Job Title
East Franklans

Drawing Title
Proposed First Floor Plan

Drawn HH	Checked CH	Date 22/06/22
Scale 1:100	Drawing No. 2201 - SK22	Revision B

Proposed First Floor Plan
Scale 1:100

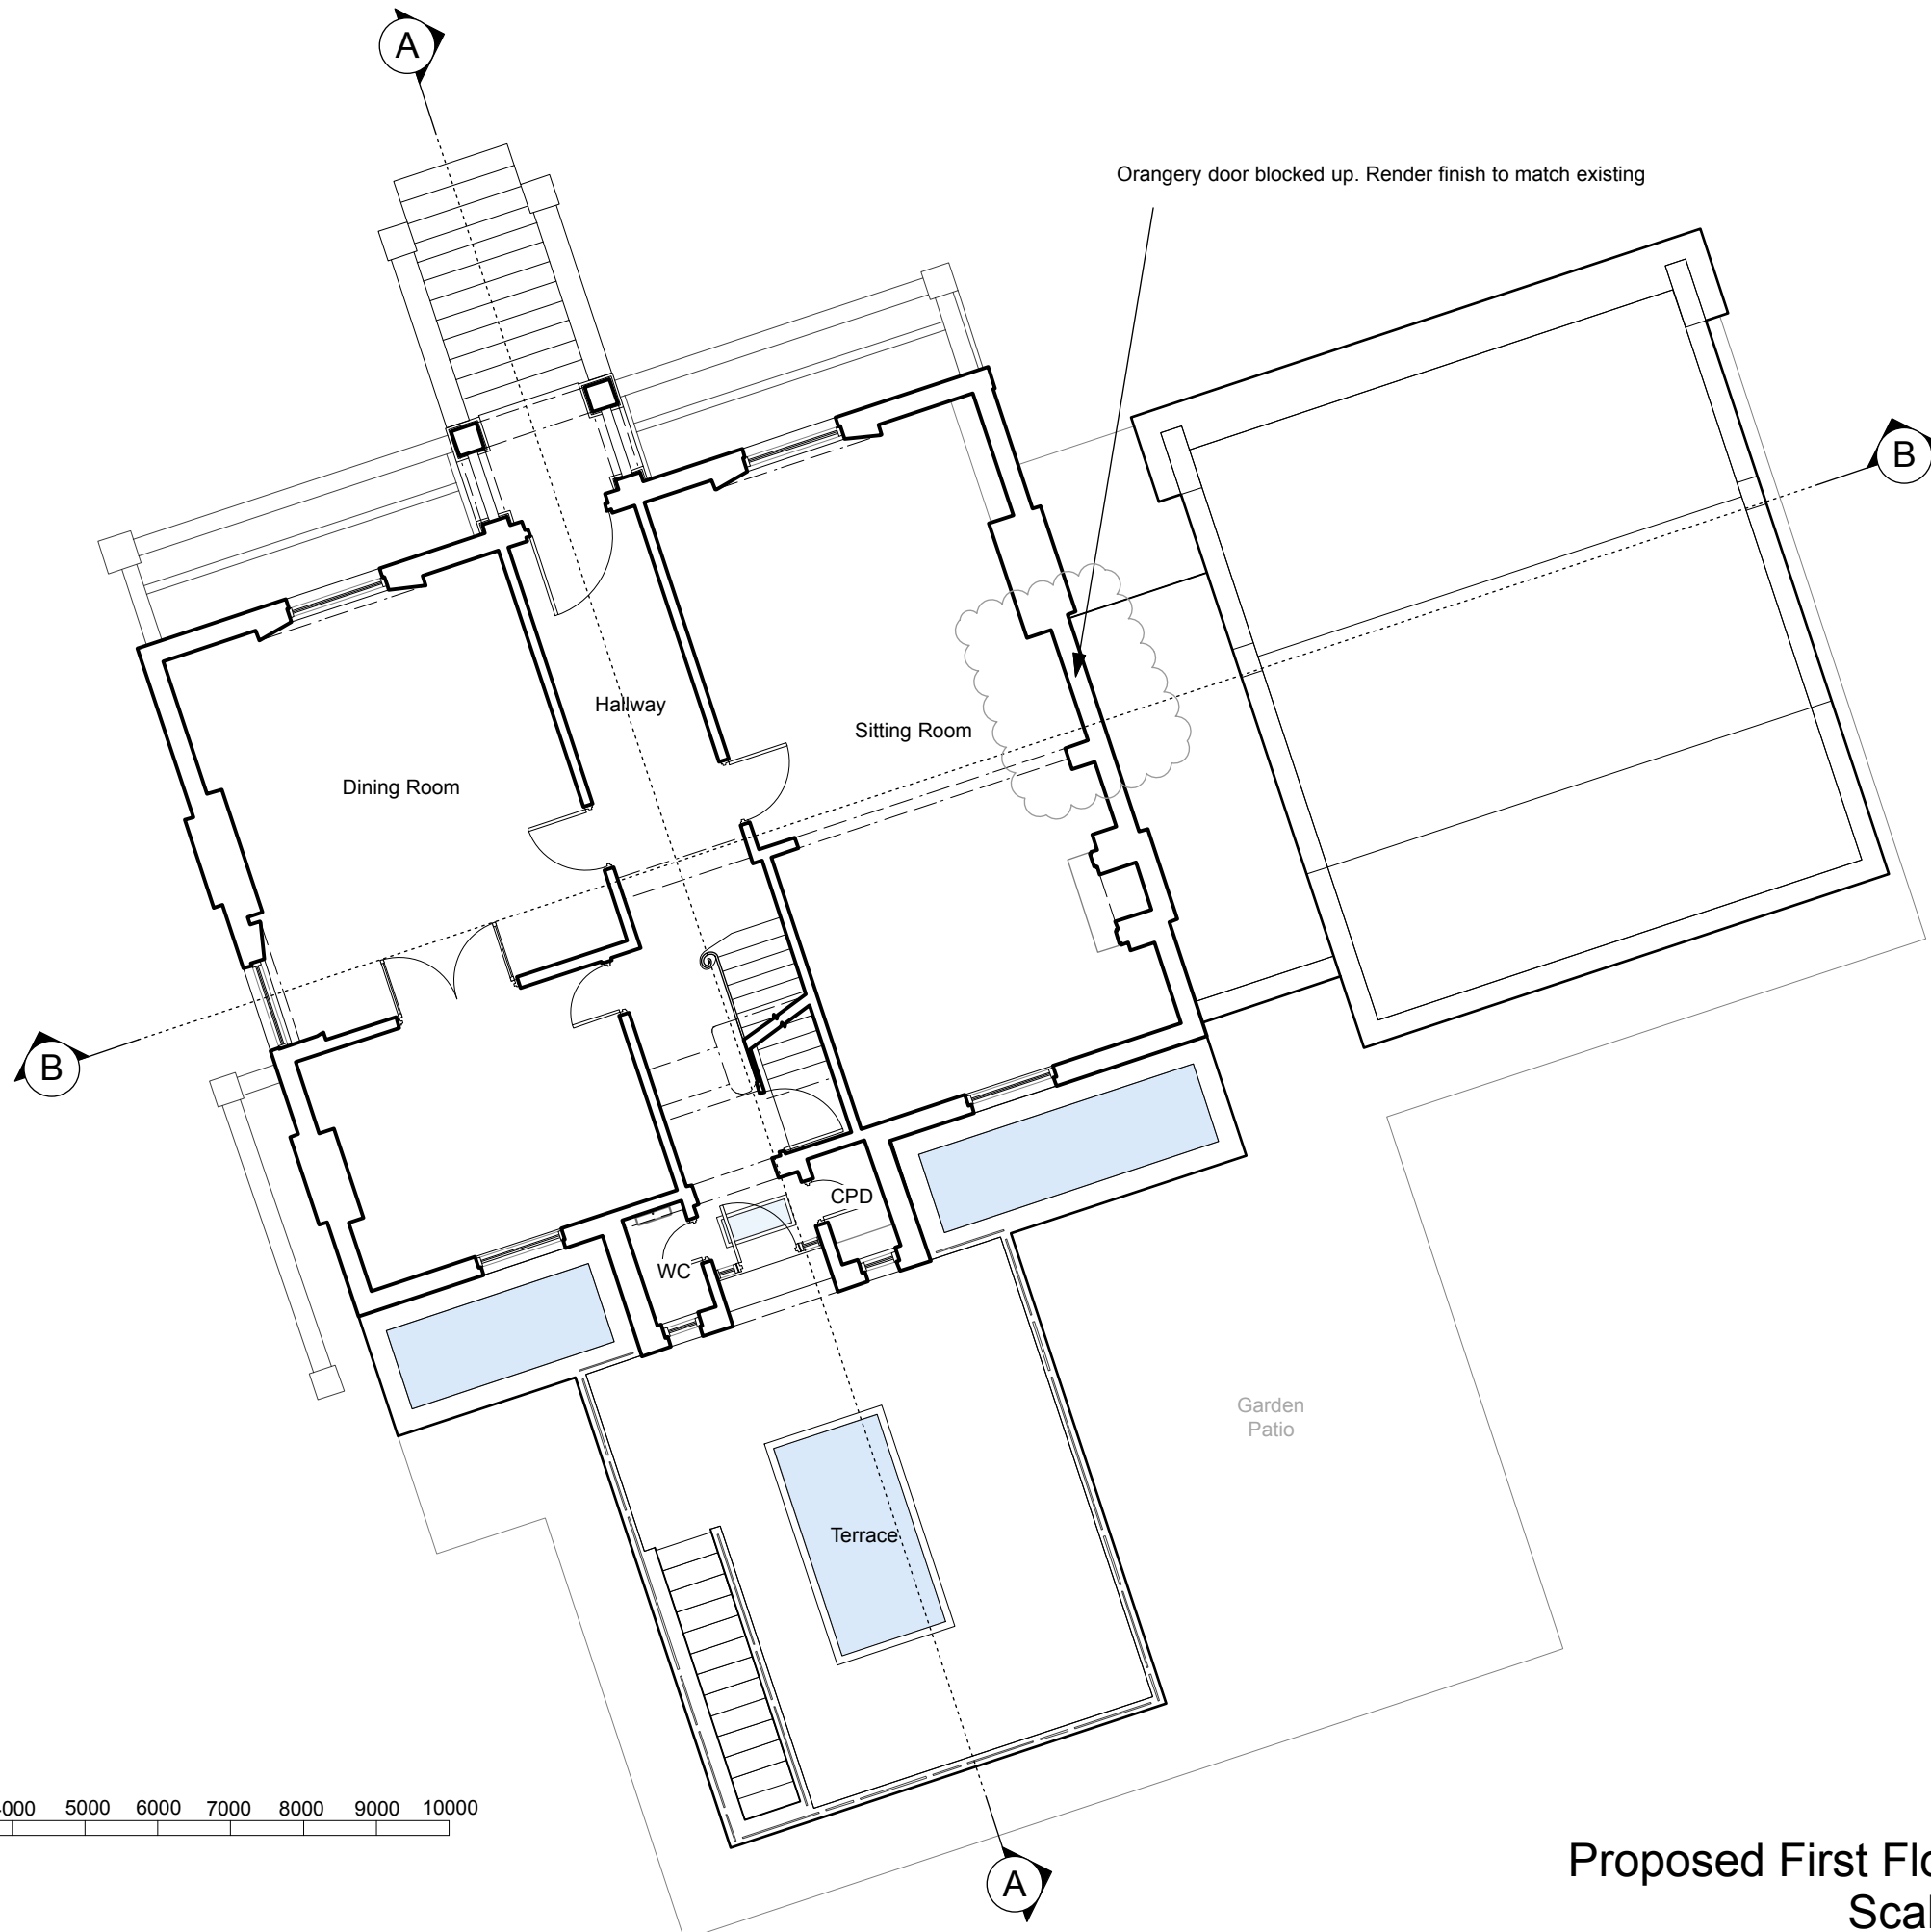
Rev	Date	Note
A	31/10/22	Balcony glazing amended to match revised elevational language
B	09/07/25	Proposed door/window revised to be blocked up.
